HP PERMIT NUMBER: HP-0801-2026

PROPERTY ADDRESS: 1123 South Newport Avenue

DISTRICT: Tracy Park

1. Replacement of windows

Window Sizes

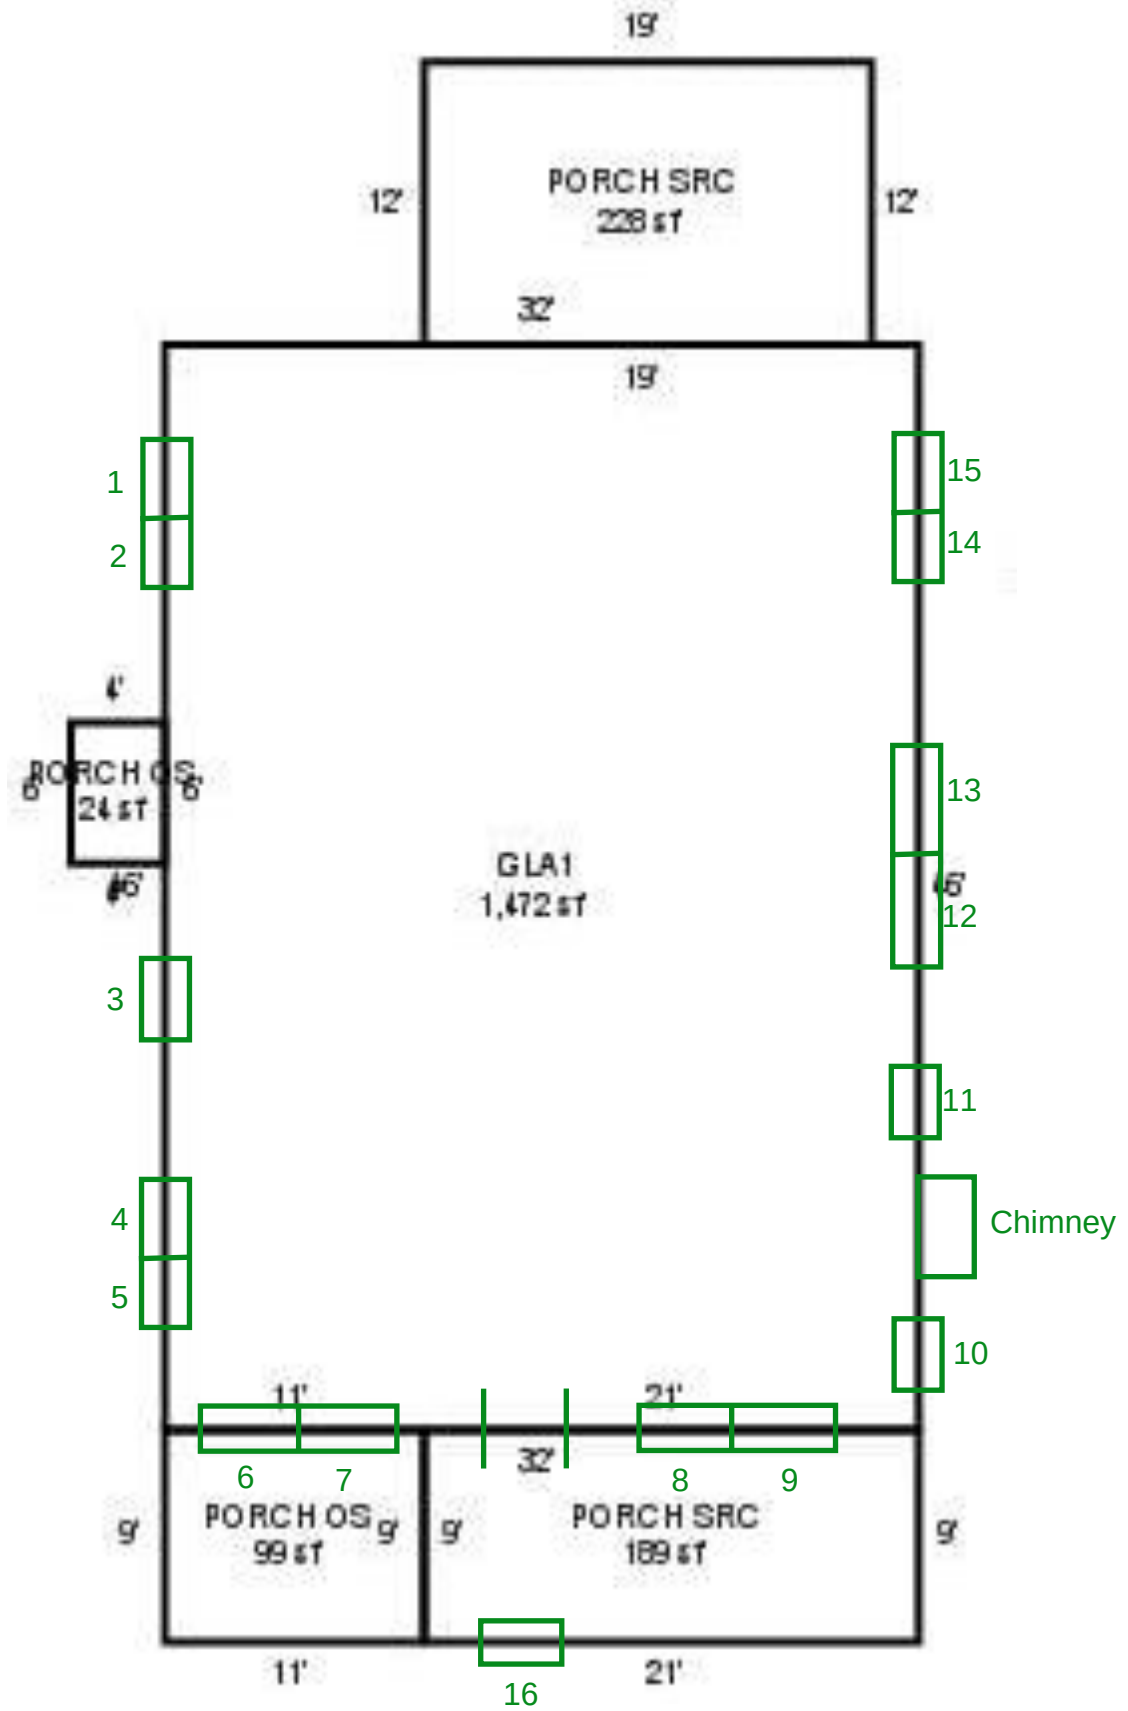
Window openings, measured during staff visit on July 13, 2026. Measurements are for entire window openings without trim, unless otherwise specified.

Windows 1-2: Unable to measure (similar to windows 4-5 and 14-15)

Window 3: 38-5/8" W x 38-1/2" H

Windows 4-5: 75-1/2" W x 63-3/4" H

Windows 6-7: 99" W x 63" H

Windows 8-9: Trim in place; each opening between trim pieces is 43-7/8" W x 57-1/4" H.
Width between outer edges of trim is 103-3/8"

Window 10: 35-1/2" W x 35" H

Window 11: 35-1/2" W x 35" H

Window 12-13: 105-3/4" W x 62" H

Window 14-15: 74-1/2" W x 63" H

Window 16: Approx. 3-1/2' W x 2' H (in gable over porch)
